Product Change Notice – PCN-IEV-2401-00

Delta Energy Systems GmbH, Tscheulinstr. 21, 79241 Teningen, Germany

PCN Title: 1kW wireless charging system design change

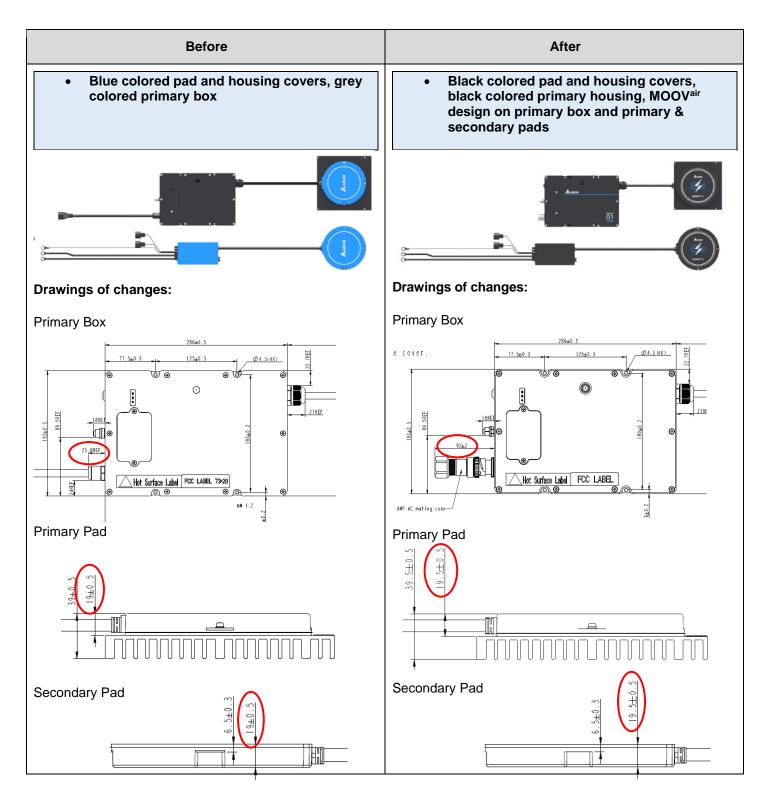
Before		After	
 AC input through 1m cable and C14 connector IP40 Primary & Secondary Pad thickness: 19.0 ± 0.5mm Primary Box color: grey Primary Pad color: blue + Delta logo Secondary Box color: grey Secondary Pad color: blue + Delta logo Packing: white / blue Delta logo 		 AC input through Amphenol* connector IP65 Primary & Secondary Pad thickness: 19.5 ± 0.5mm Primary Box color: black + MOOV^{air} brand Primary Pad color: black + MOOV^{air} brand Secondary Box color: black Secondary Pad color: black + MOOV^{air} brand Packing: plain carton with MOOV^{air} brand 	
Product Name	Order Part Number	Product Name	Order Part Number
WPU 1000W 1AC US	EOE14010738		
WPU 1000W 1AC EU	EOE14010739	WPU 1000W 1AC EOE14011131	
Product Name	Order Part Number	Product Name	Order Part Number
WSU 1000W 24V	EOE14010740	WSU 1000W 24V	EOE14011207
WSU 1000W 36V	EOE14011105	WSU 1000W 36V	EOE14011208
WSU 1000W 48V	EOE14010803	WSU 1000W 48V	EOE14011209

Apart from the functional modification of the AC input connector, there are no other changes regarding fit, form, or function. Interoperability with existing devices is ensured.

*Amphenol mating connector is included in WPU.
